NOTICE OF PUBLIC MEETING CITY OF MILLERSBURG PLANNING COMMISSION

File No: CUP 19-01 and SP 19-01 Evening Star Manufactured Home Park

Proposal: The applicant is proposing a Conditional Use Permit and Site Plan Review for a 28 space senior manufactured home park with four proposed guest parking spaces, drainage features, one open space area, landscaping, and one proposed point of access from NE Millersburg Drive.

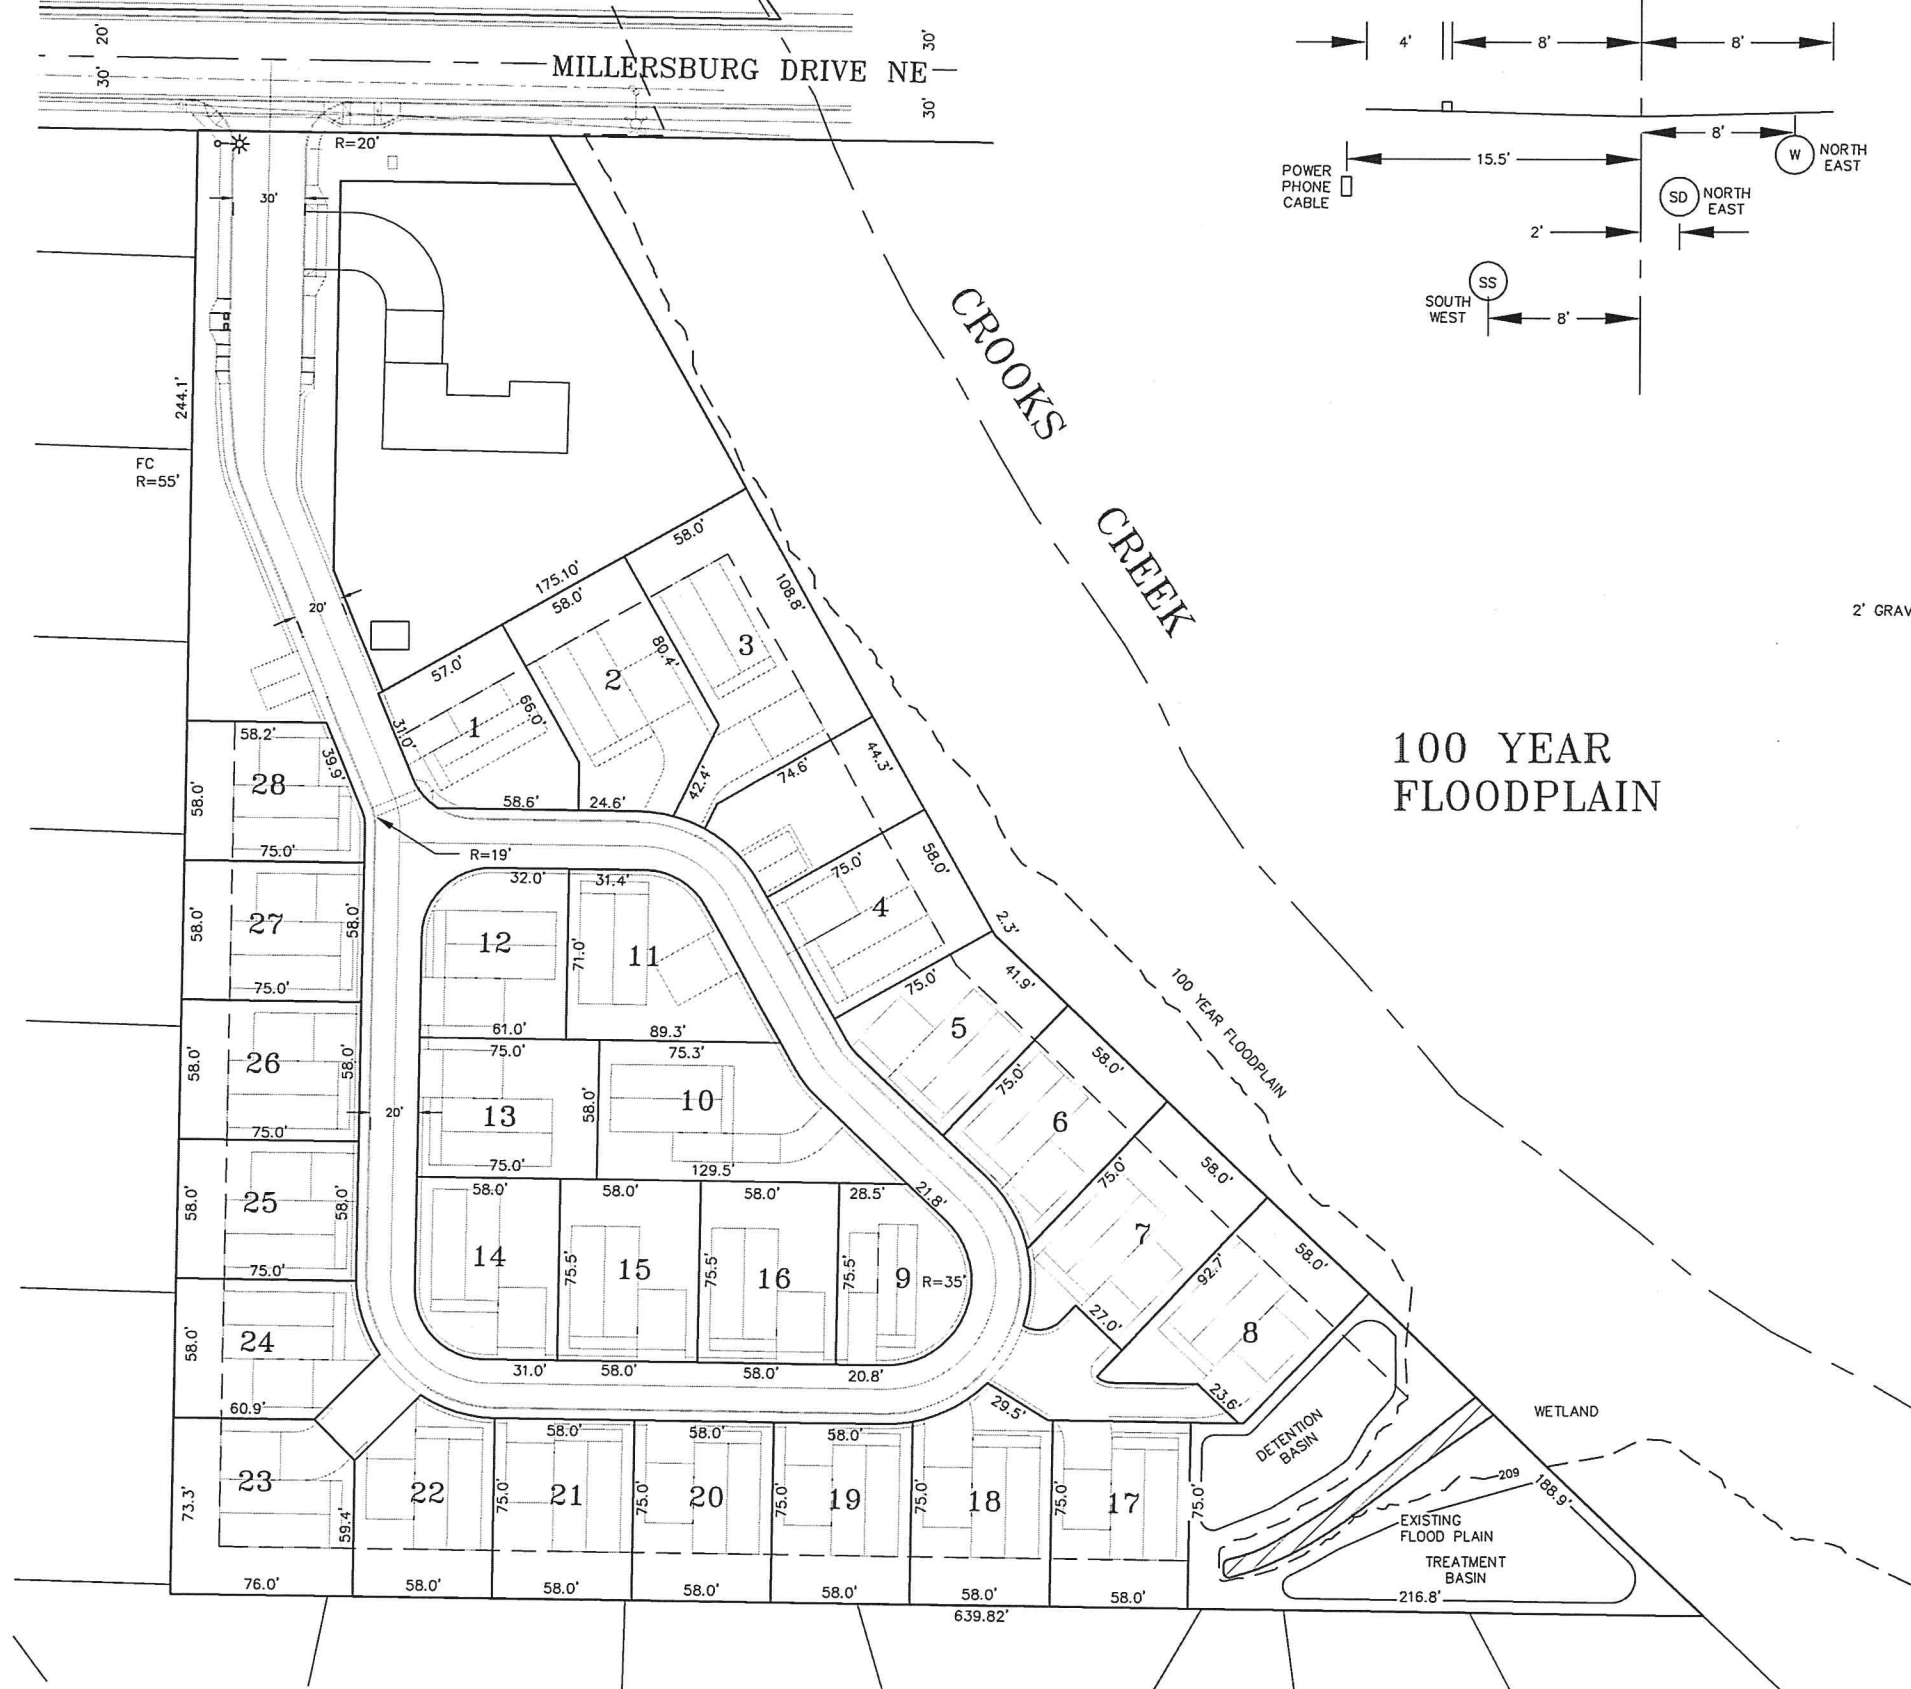
It appears that the applicant designed the internal streets using table 10-C of Chapter 10 in the OMDPSC (see table below). The site plan shows an internal street width of 20 feet. The City Code in Section 6.165, the manufactured home park standards, explains that when there is a conflict between the City Code and the OMDPSC, the State standards in Chapter 10 shall govern. As designed, the applicant is proposing a two-way street with no parking on either side. Based on the table, that would require a 20-foot pavement width.

However, the City and the Albany Fire Department, in their letter dated March 12, 2019, have expressed concerns with the lack of on-street parking. The 20-foot pavement width would require that no on-street parking be permitted. The City Manager, Kevin Kreitman, who previously served as a Fire Chief for the City of Albany, Oregon, and later for Redding, California, and the letter from the Albany Fire Department, have explained that people will often ignore no-parking signs and still park on the street. The Planning Commission has expressed similar concerns previously with street designs that do not allow on-street parking, going so far as to request that 'skinny streets' be removed for the Code during the next forthcoming Code revision. Illegal parking on these posted no-parking streets presents a public health and safety concern. When a car is illegally parked on a 20-foot pavement width, the ability for a fire or emergency vehicle to navigate the project site is significantly restricted, creating a dangerous situation and hazard. Alternatively, when on-street parking is allowed, the 20-foot pavement width is maintained because the design of the street allows for cars to safely park on the side of the street. In addition, local law enforcement does not have jurisdiction to enforce no-parking requirements on private streets. Therefore, there is no mechanism to insure on-street parking will not occur.

Because the proposed project is a conditional use permit³, the Planning Commission has the authority to impose conditions deemed necessary for health, safety and welfare. Staff is recommending that the Planning Commission require, through conditions of approval, that the internal streets permit parallel, on-street parking on both sides. Based on the OMDPSC Table 10-C (below) the State would then require a pavement width of 30 feet.

ANALYSIS: The internal street, as shown on the applicants exhibit and outlined in their narrative, is consistent with the City standards where it meets NE Millersburg Drive and for 100 feet from NE Millersburg Drive. The project does not abut any other City street. The street standards for the rest of the internal streets have been discussed previously in this staff report for criterion C. Conditions have been added to re-design all internal streets to match City standards.

PROPOSED CONDITION OF APPROVAL: The applicant shall revise the site plan showing all internal streets with a minimum curb to curb width of 32 feet, allowing for parking on one side of the street. Streets shall be signed to allow parking on one side only. Should the inclusion of these requirements significantly change the design of the project, the Planning Commission will be required to review the revised design using the site plan review process.

PROPOSED CONDITION OF APPROVAL: The applicant shall revise the site plan showing all internal streets with 5-foot sidewalks on both sides and 4-foot planter strips separating the sidewalks from the curbs. The minimum full street width, sidewalk to sidewalk shall be at least 50 feet, to allow safe pedestrian circulation consistent with the code. Should the inclusion of these requirements significantly change the design of the project, the Planning Commission will be required to review the revised design using the site plan review process.

5. The applicant shall revise the site plan showing all internal streets with a minimum curb to curb width of 32 feet, allowing for parking on one side of the street. Should the inclusion of these requirements significantly change the design of the project, the Planning Commission will be required to review the revised design using the site plan review process.

6. The applicant shall revise the site plan showing all internal streets with 5-foot sidewalks on both sides and 4-foot planter strips separating the sidewalks from the curbs. The minimum full street width, sidewalk to sidewalk shall be at least 50 feet, to allow safe pedestrian circulation consistent with the Code. Should the inclusion of these requirements significantly change the design of the project, the Planning Commission will be required to review the revised design using the site plan review process.

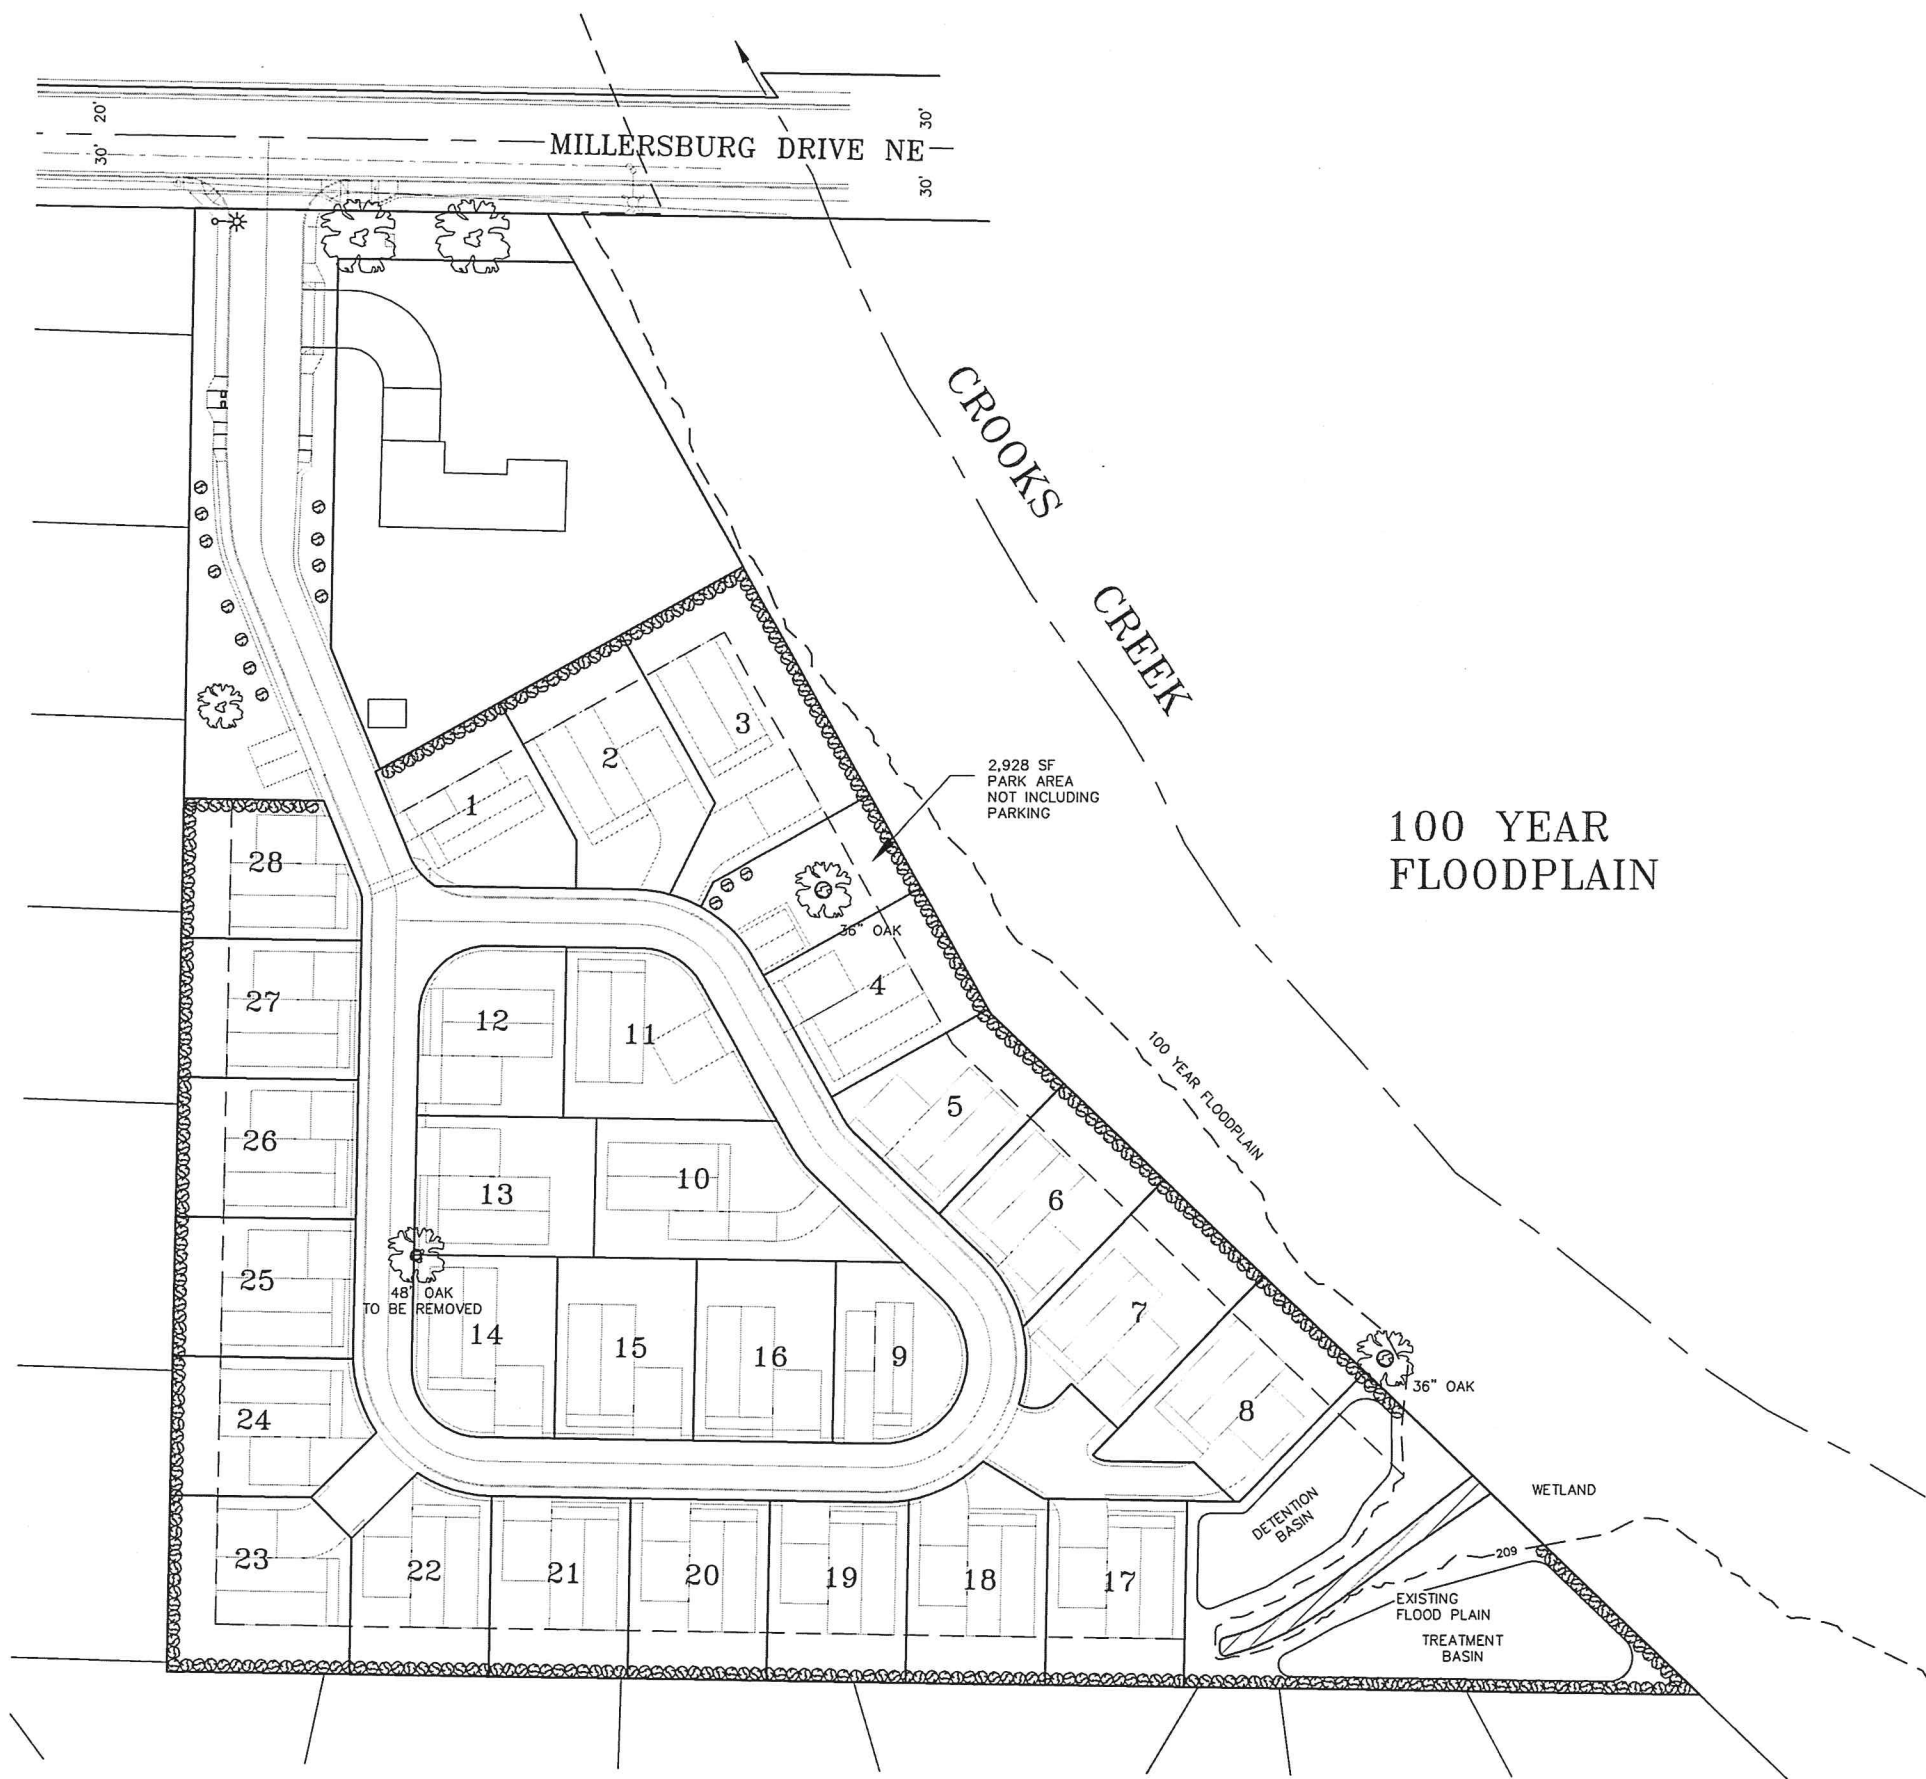
ANALYSIS: The proposed project is required to provide landscaping consistent with this code section. The landscape plan submitted was a preliminary plan that did not contain sufficient detail to satisfy the requirements of Section 5.134 (b). A condition of approval proposes the submittal of a more detailed landscape plan to show conformance with all aspects of Section 5.134, including screening, street trees and front yard landscaping. Any screening required in Section 5.134(9) is superseded by the screening requirement specific to manufactured housing (listed in Section 6.135).

ANALYSIS: The applicant submitted a preliminary landscape plan. Alone, it does not show full conformity with these requirements. The applicant's narrative expands on the exhibits to say that he will comply with the requirements. Previously a condition of approval was proposed by staff that would require a more detailed landscape plan that would show conformity with these requirements.

ANALYSIS: The applicant's narrative goes into detail regarding how the applicant intends to meet the screening requirements. First, it is important to note that the project site sits below grade from the neighbors that surround the site on the west and south. Staff asked the applicant to provide an additional sight line exhibit showing a section diagram with the elevation difference, the existing units surrounding the site and the proposed unit locations to clarify how the grade difference impacts the project. This exhibit, attached, was provided but did not provide enough detail to clearly show the line of sight for what the existing homes will see if the project were approved and constructed.

The screening described in the Code above was clearly intended for a situation where the neighbors were at grade. Further, it is clear that the Code's intent is to assure that the manufactured homes cannot be seen from the neighboring property. The grade separation is a unique site feature. Indeed, the Code anticipated that not all circumstances would be as clear cut as the listed requirements seem to imply. The Code allows the Planning Commission to require additional screening if needed. In this case, in order for the applicant to meet the intent of the Code, additional screening will be required.

The applicant has explained in the narrative and shown on the site plan that they intend to plant 5-foot Leyland Cypress trees along the entire outer park perimeter. Their narrative explains that within 2 years these should screen 80% of the view from the park boundary. Property to the east is additionally separated by Crooks Creek, thus these properties to the east should be adequately screened with the proposal. The neighbor to the north is also at grade with the project site, thus the screening proposed by the applicant should be sufficient for this neighbor.

PROPOSED CONDITION OF APPROVAL: The applicant shall submit detailed landscape and irrigation plans showing conformance with Section 5.134 and all other landscape requirements.

PROPOSED CONDITION OF APPROVAL: The applicant shall include one additional sight obscuring, large canopy tree on each unit space along the south and west of the park, including along the west side of the entry drive. The trees should be at least 24" box in size, 7 feet tall at planting, and that will grow to substantial canopy within 5 years, at which time they must provide at least 80% opacity when viewed from at least 6 feet in height from a perpendicular line of sight. The canopy at full growth should not overhang the property lines of the park site. All planting must be completed prior to occupancy of any manufactured home.

11. The applicant shall include one additional sight obscuring,- large canopy tree on each unit space along the south and west of the park, including along the west side of the entry drive. The trees should be at least 24" box in size, 7 feet tall at planting, and that will grow to substantial canopy within 5 years, at which time they must provide at least 80% opacity when viewed from at least 6 feet in height from a perpendicular line of sight. The canopy at full growth should not overhang the property lines of the park site. All planting must be completed prior to occupancy of any manufactured home.
